BOARD ACTION REPORT – APPEALABLE ITEM

Project Name:	230 George Bush Boulevard
Project Location:	230 George Bush Boulevard, Del-Ida Park Historic District
Request:	Certificate of Appropriateness (2019-268)
Board:	Historic Preservation Board
Meeting Date:	October 2, 2019

HISTORIC PRESERVATION BOARD STAFF REPORT											
230 George Bush Boulevard											
Meeting	File No.	Application Type									
September 4, 2019	2019-268	Class II Site Plan and Certificate of Appropriateness									
REQUEST											
		an of a Olara II Otta Dian Madification and Ocatificate of

230 GEORGE BUSH BLVD GARAGE ADDITION

FIE NUMBER FIE NUMBER BROPOSED SITE PLAN SITE PLAN DATE 03.22.17 JOB NUMBER 20150616 DRAWING NUMBER A1.01	A PER PER OWNER TO PER OWNER TO PER OWNER TO RECOMMENDATIONS TO PER PER OWNER TO RECOMMENDATIONS TO PER OWNER TO RECOMMENT.
---	---

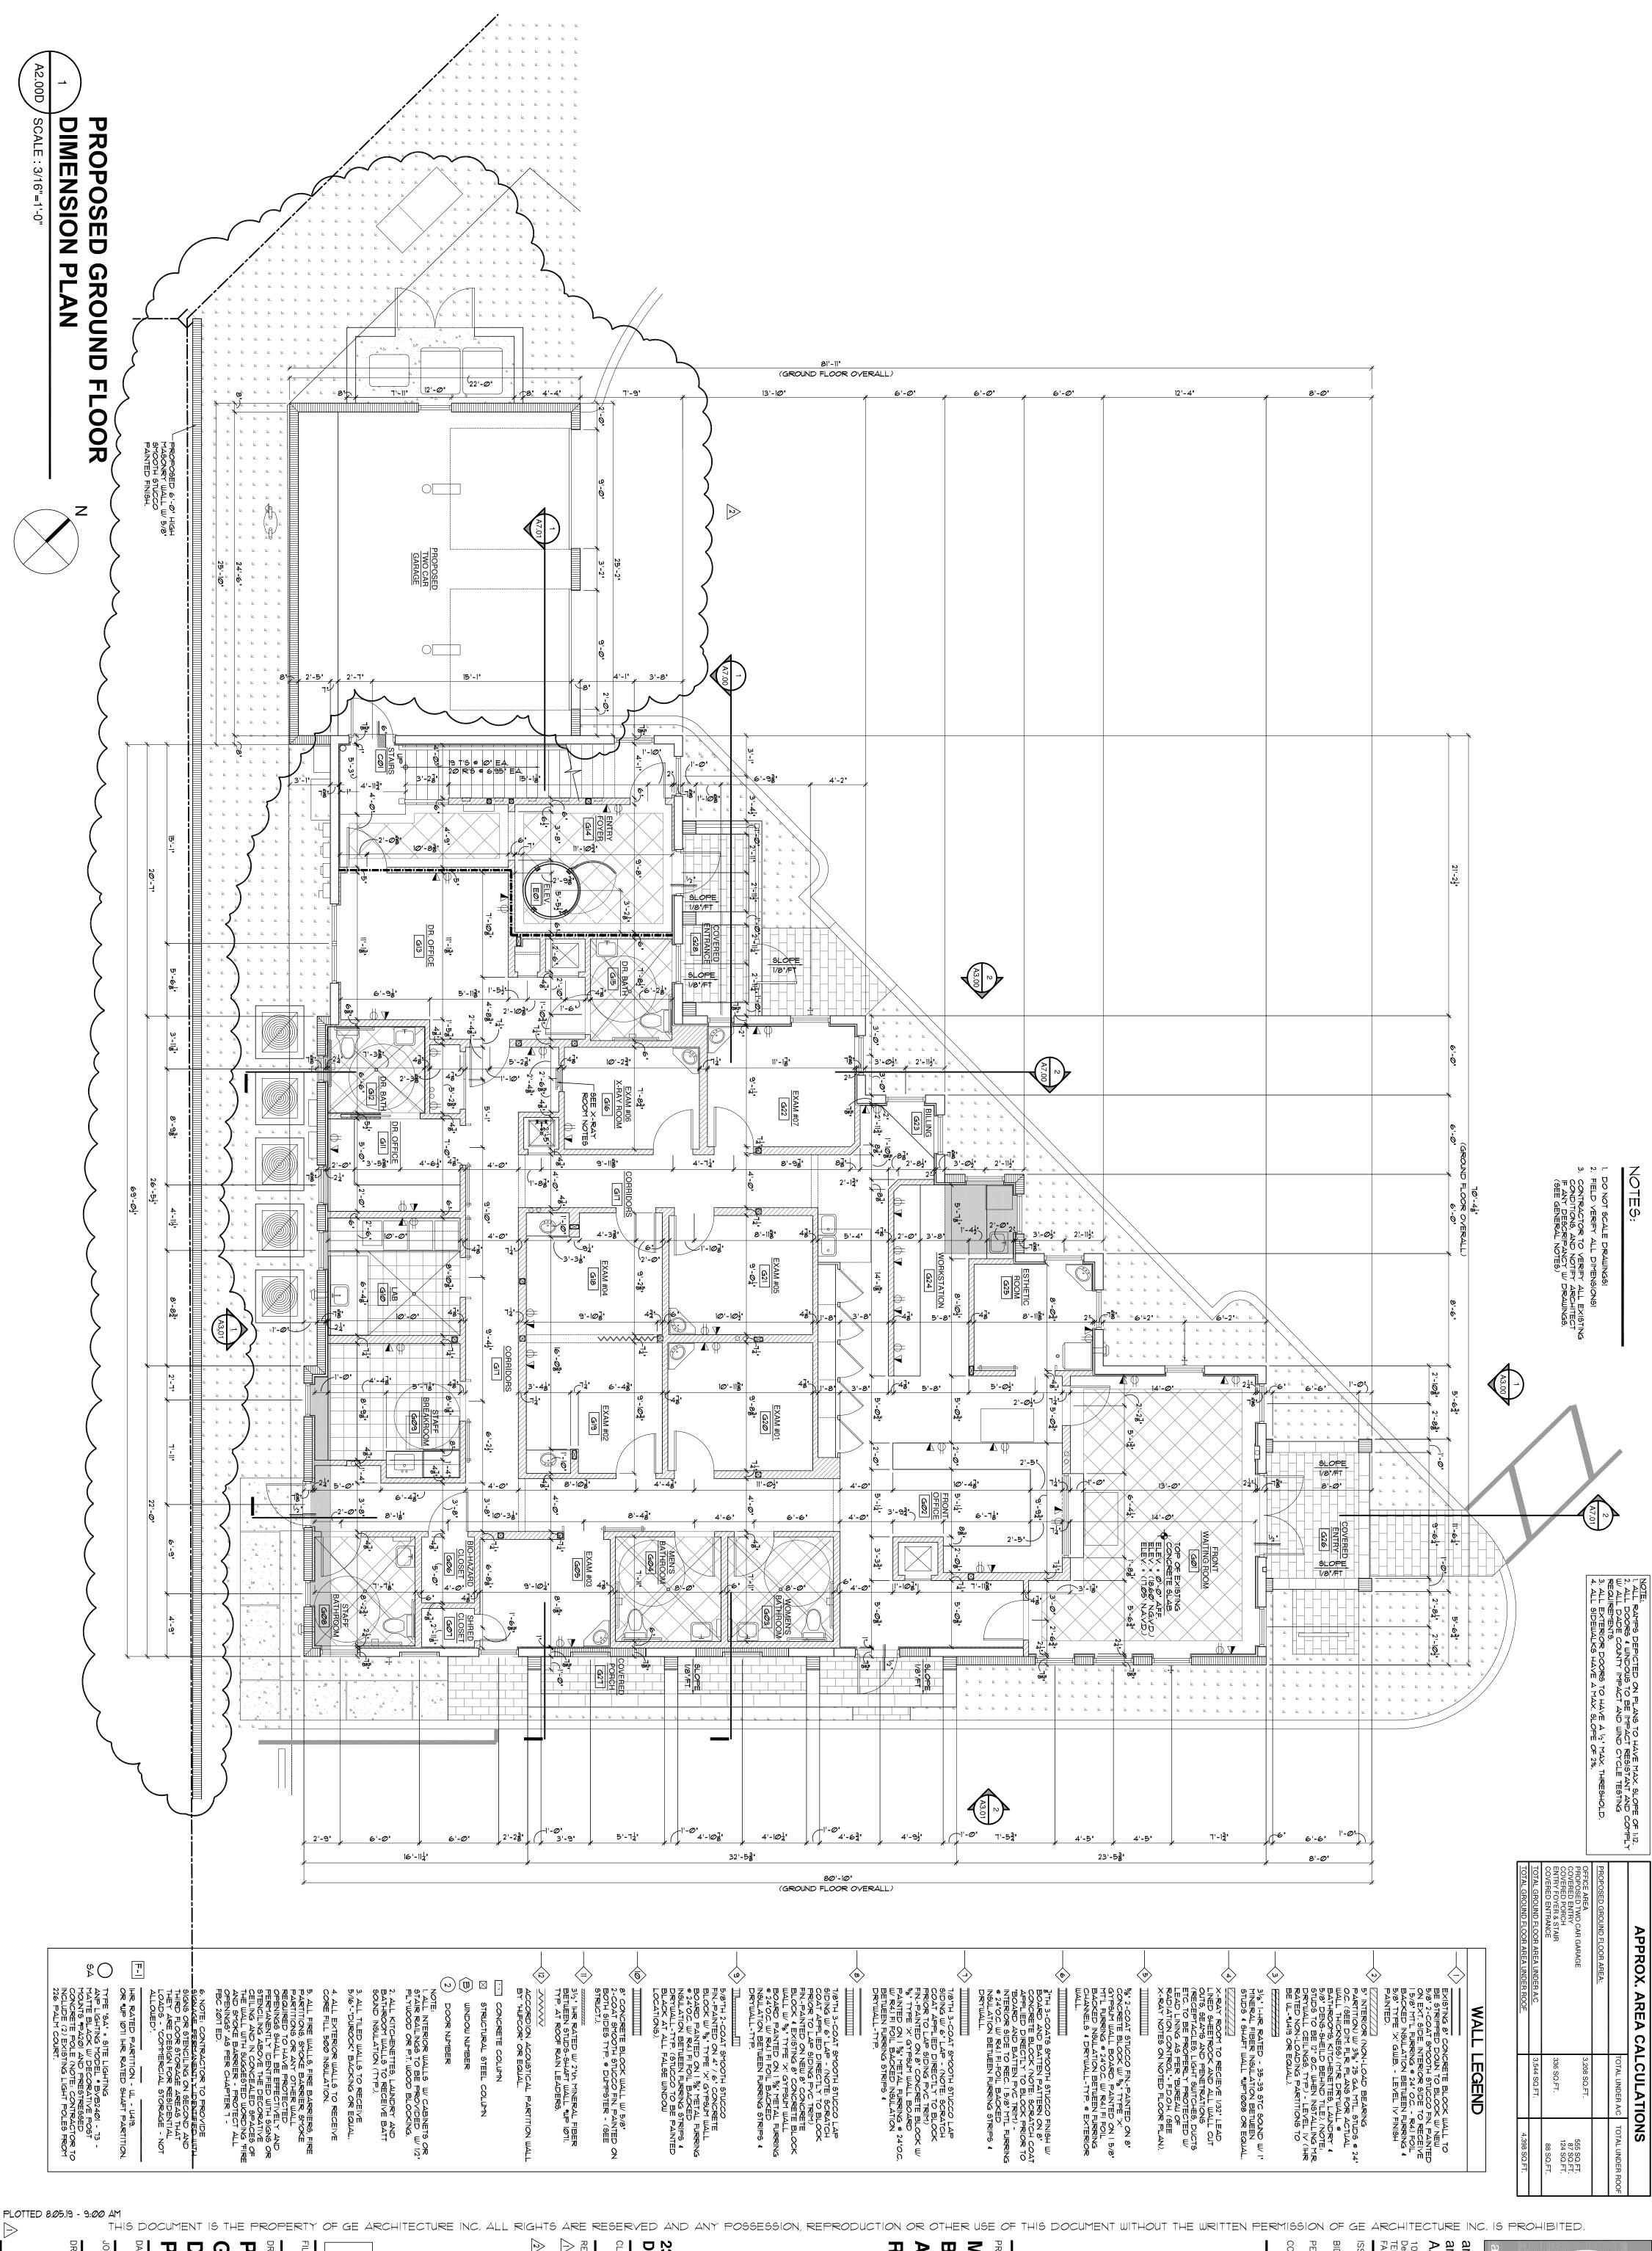
- 1. Add details and elevation drawings for refuse area to site plan and elevation sheets;
- 2. Depict and illustrate proposed charging station location on site plans; and,
- 3. Provide a Notice of Acceptance for the garage doors.
- D. Deny Certificate of Appropriateness (2019-268), for the property located at 230 George Bush Boulevard, Del-Ida Park Historic District, by finding that the request is inconsistent with the Comprehensive Plan and does not meet the criteria set forth in LDR Sections 2.4.5(G), 2.4.6(H)(5), and 2.4.5(I)(5).
